INDESIT company

IDL60SEU.2

F032225

General notes

N1045072FIG1

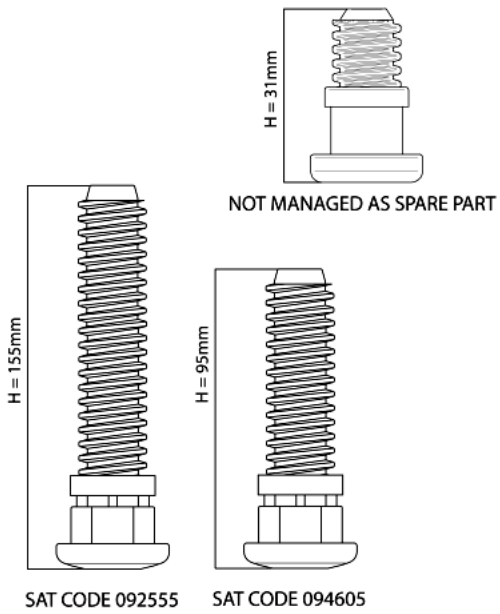
N1045072: Introduction of fixed rear foot H=31mm on free-standing models.

From serial no. 40218.0001, free-standing dishwashers affected by this modification have been equipped with new fixed rear feet (H=31mm).
The new foot replaces the adjustable one (H=155mm) Service code 092555; on the EVO3 range with TurboDry the new foot replaces the adjustable foot (H=95mm) Service code 094605.
The Spare Part Warehouse will continue to manage only 155mm and 95mm adjustable feet as they are interchangeable with the fixed 31mm foot.
The three feet are shown in illustration N1045072FIG1.

N1045083FIG1

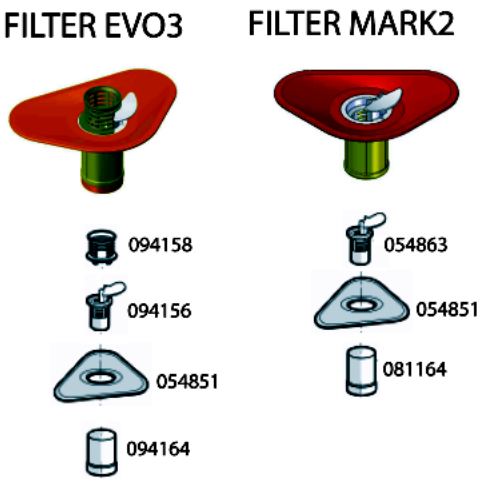
n1045083: Modification of filters on EVO3 60 cm dishwashers

All dishwasher models affected by this modification have been equipped with the items listed below, in order to solve the drain pump clooging problem.

Introduction of:
Cylindrical plastic filter code 081164
Central filter code 054863

Elimination of:
Cylindrical plastic filter code 094164
Central filter code 094156
Central filter grid code 094158

The modification has been introduced progressively, starting from serial no. 40516.0001.

n1045085: Introduction of new litre counter turbine integrated on air-break.

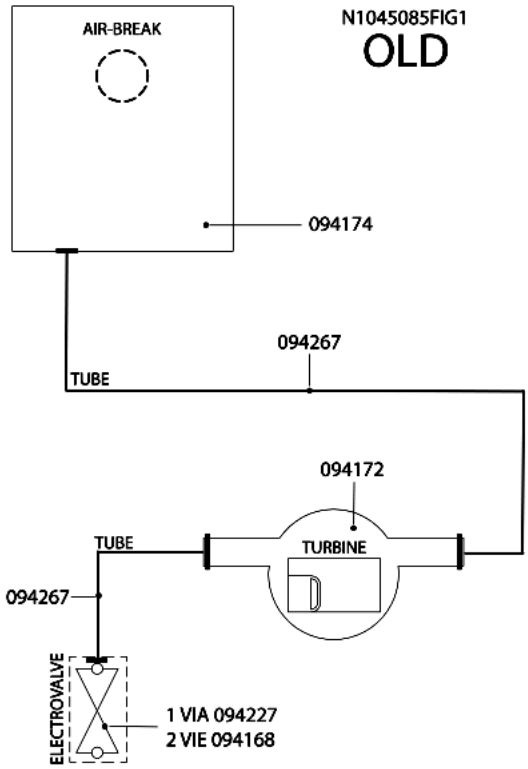
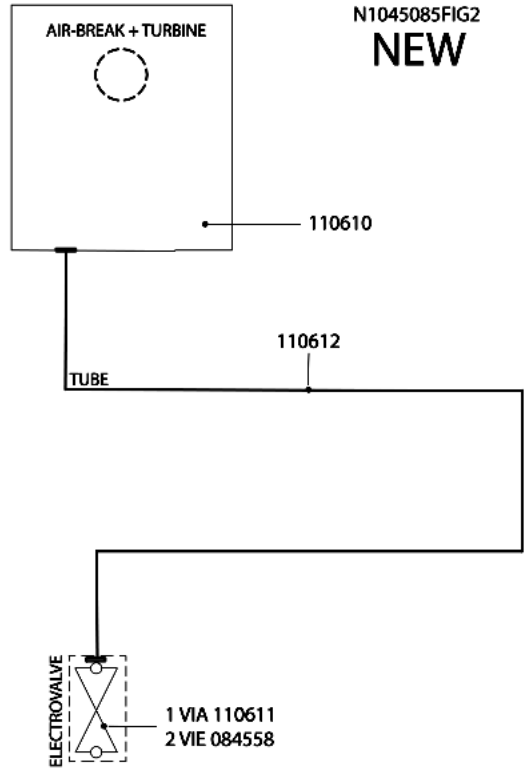
All dishwashers affected by this note have been equipped with a new litre counter turbine on the air-break.
Picture N1045085FIG1 illustrates the premodification structure, picture N1045085FIG2 the new structure.

Items affected by the modification.

AIR-BREAK:
new 110610;
premodification 094174;
the new item features a new integrated litre counter turbine and its water supply hose has a smaller diameter.

LITRE COUNTER TURBINE code 094172 has been eliminated.

SOLENOID VALVES:
new:
1-WAY code 110611;
2-WAY code 084558(Rohs 143737);
premodification:
1-WAY code 094227;
2-WAY code 094168;
the new solenoid valves have a smaller diameter drain hose fitting.

HOSES:
new solenoid valve hose/air-break code 110612;
premodification turbine hose/air-break code 094267;
premodification solenoid valve hose/air-break code 094267;
the new hose has a smaller internal diameter.

WIRING:
the litre counter turbine connecting cable is longer, but since the connector is the same, the new item can be used in place of the premodification one.
